#2023-35
997 North Shore Drive – Variations
Project Review for Planning and Zoning Commission

Meeting Date: April 5, 2023

Location: 997 North Shore Drive

Exhibit A
Petitioner's Proposed Building Footprint

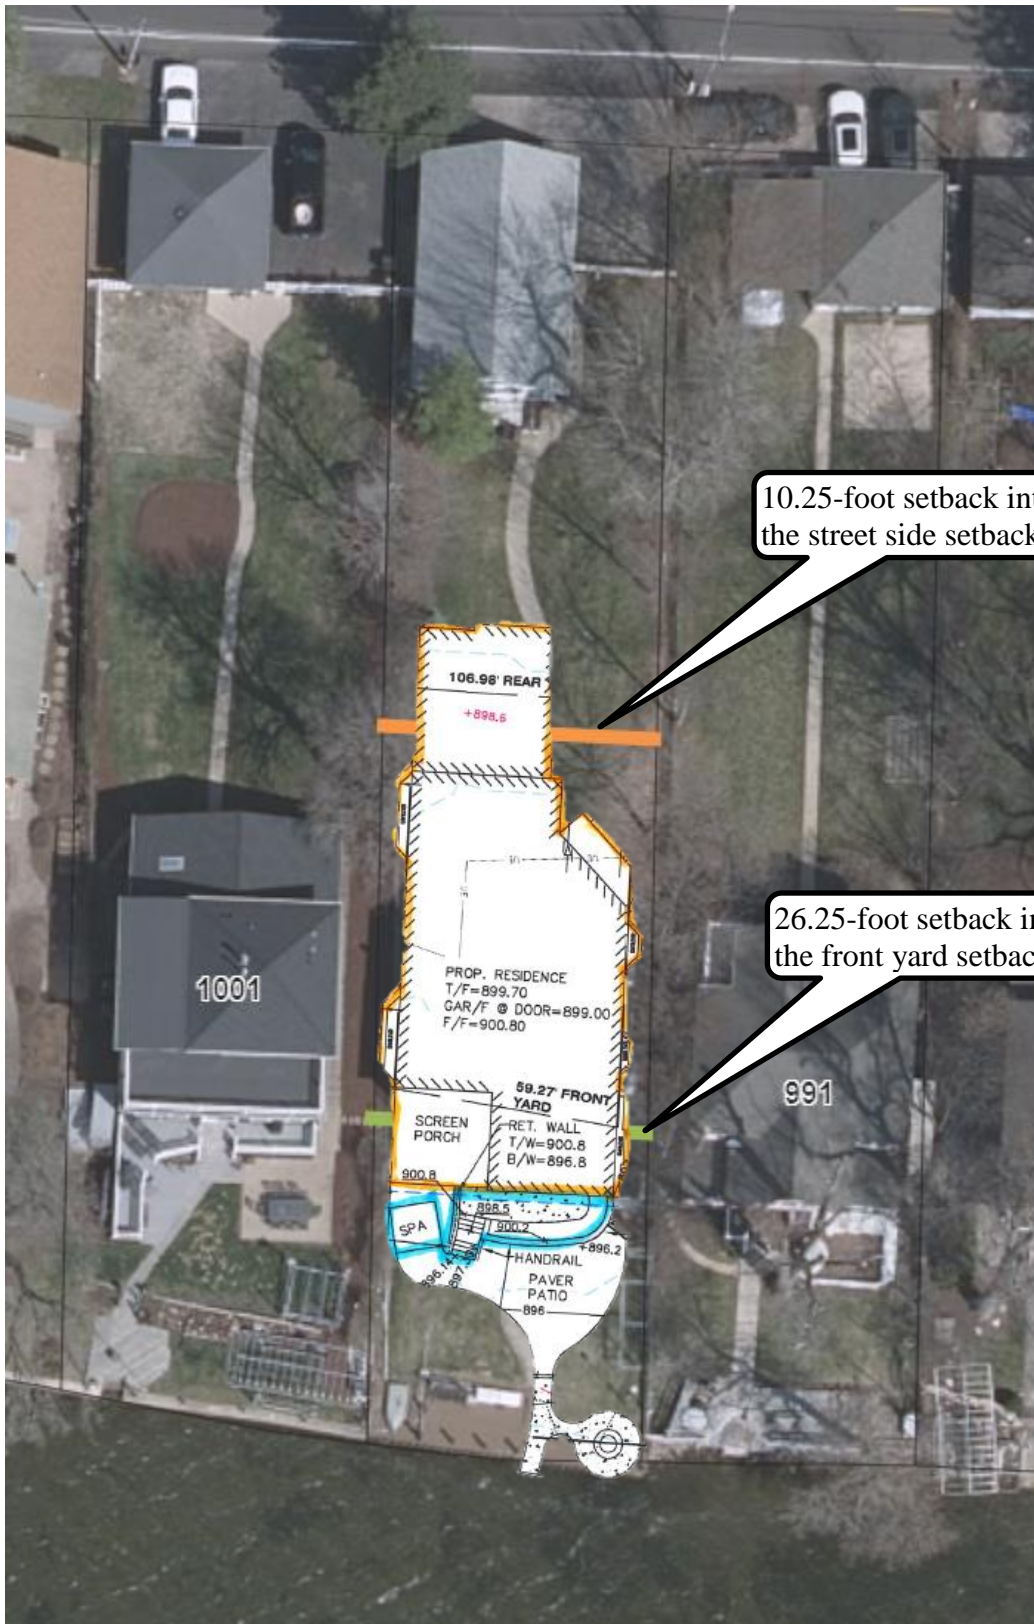
- Staff has reviewed the proposed location of the house and offers two suggestions for relocation to reduce or amend the requested variations. The exhibits at the end of the report illustrate the proposed footprint and two modified footprints which pull the house farther away from the lakefront.
